REMARKS

The drawing sheets attached in connection with the above-identified application containing Figures 1-6 are being presented as a new formal drawing sheet or sheets to be substituted for the previously submitted drawing sheet or sheets. The drawing Figures 1-6 have been amended. Appended to this amendment is an annotated copy of the previous drawing sheet which has been marked to show changes presented in the replacement sheet of the drawing.

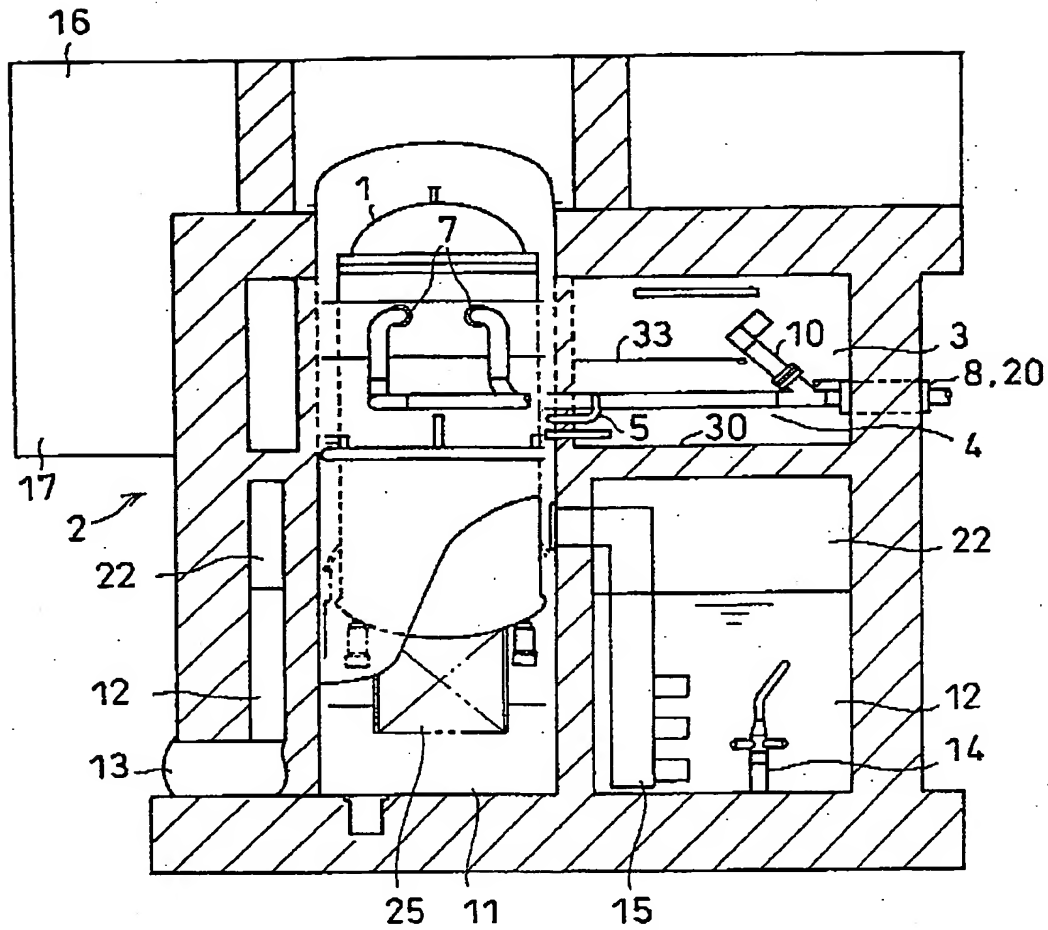
The specific changes which have been made to Figures 1-6 are to make the view numbers larger than the numbers used for reference characters. Figures 5-6 are also amended to include the legend "PRIOR ART".

FIG. 5

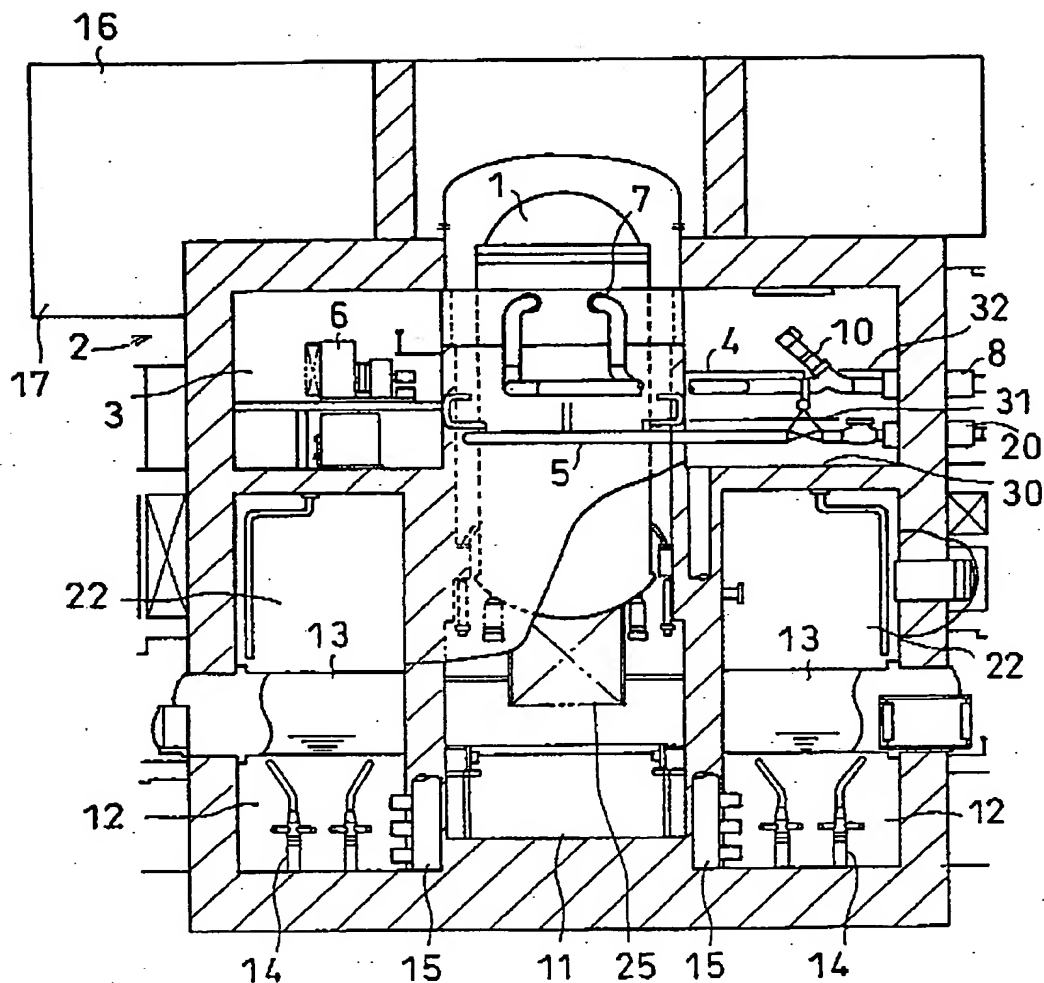
The drawings were objected to. Applicants have amended Figures 5 and 6 to label them as "PRIOR ART", and amended Figures 1-6 to make the view numbers larger than the numbers used for reference characters. Accordingly, applicants submit that the objection to the drawings has been overcome.
